# REGULAR MEETING OF THE UNITED LAGUNA WOODS MUTUAL ARCHITECTURAL CONTROL AND STANDARDS COMMITTEE

# Thursday, October 17, 2019 – 9:30 a.m. Laguna Woods Village Community Center Elm Room 24351 El Toro Road

SUBJECT: Variance Request: Mr. Tae Young Yoon of 769-B (La Corona, 3B)

**Extend Dining Room into Front Patio**

**ELEVATION A**

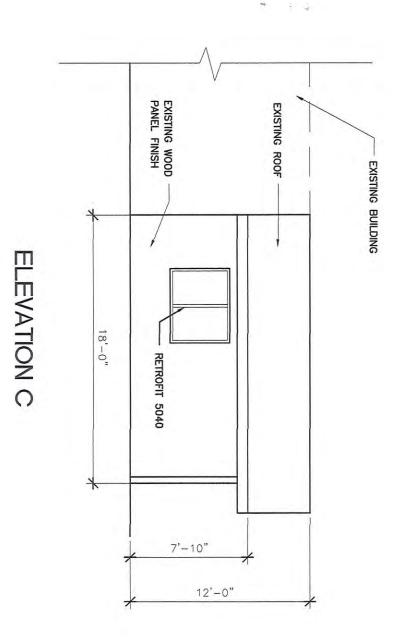
The new front exterior wall would contain a 36" wide by 6'8" tall entry door with a 3'-0" wide by 2'-6" tall trapezoid window above, alongside a sliding window measuring 5' wide by 5'6" tall. Headers of both door and adjacent window would be level.

The right elevation would contain a 9'-6" wide by 4'6" white vinyl window, while the rest of the wall would be stucco to match existing.

SECTION A-A

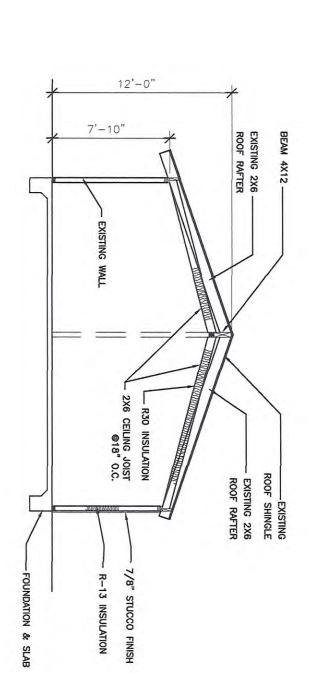
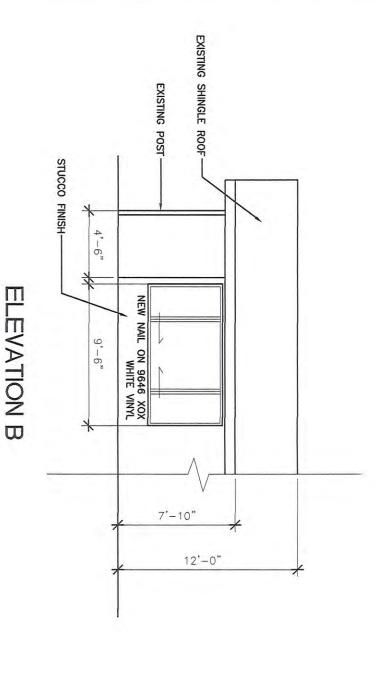
The room extension will take place under the existing alteration shingle roof that was recorded installed above the patio in 2001 and has been maintained as part of the United Mutual Re-Roofing program. The existing alteration skylights will be removed, and replaced with a new 4'-0" wide by 4'-0" long skylight that will be installed within the existing roof framing.

The sliding glass door and wall between the kitchen and patio will be removed and a new concrete slab will be poured to raise the room extension to match the rest of the unit. Structural drawings are required; footings will be inspected and reinforced where deemed necessary by a licensed engineer prior to construction.
